Well Name: RAGIN CAJUN 12-13 FED COM	Well Location: T26S / R34E / SEC 12 / NWNE / 32.063668 / -103.421741	County or Parish/State: LEA / NM
Well Number: 8H	Type of Well: OIL WELL	Allottee or Tribe Name:
Lease Number: NMNM100567	Unit or CA Name:	Unit or CA Number:
US Well Number: 3002548514	Well Status: Approved Application for Permit to Drill	Operator: DEVON ENERGY PRODUCTION COMPANY LP

Sundry ID: 2764397

Type of Submission: Notice of Intent	Type of Action: APD Change
Date Sundry Submitted: 12/06/2023	Time Sundry Submitted: 10:42
Date proposed operation will begin: 12/04/2023

Procedure Description: Devon Energy Production Company, L.P. respectfully requests the following changes to the approved APD: Casing program change: Surface, Intermediate, & Production casing changes. Cement volume changes to accommodate casing change. Defining well designation change to Ragin Cajun 12-13 Fed Com 13H Please see attached revised C-102, spec sheets, and drill plan.

WELL LOCATION AND ACREAGE DEDICATION PLAT

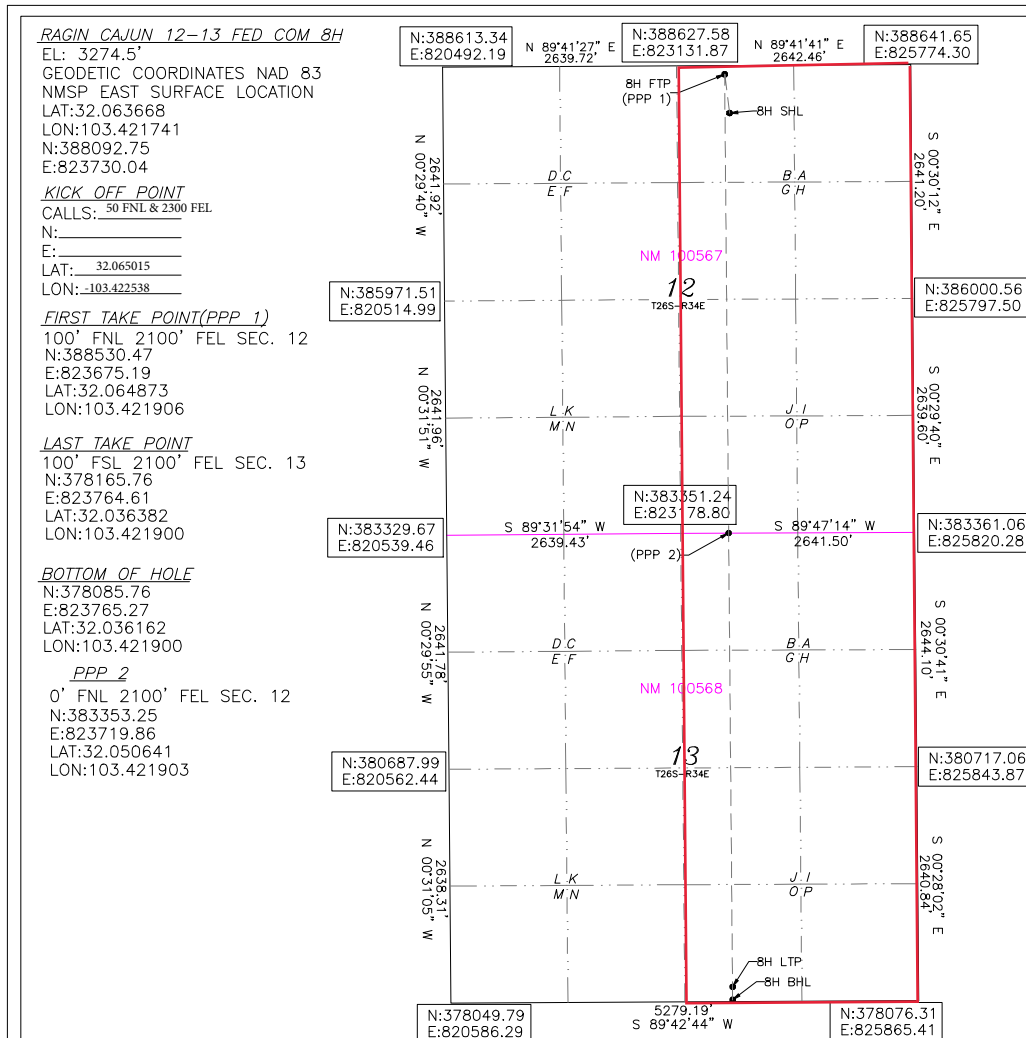
Defining well designation change to Ragin Cajun 12-13 Fed Com 13H

Please see attached revised C-102, spec sheets, and drill plan.
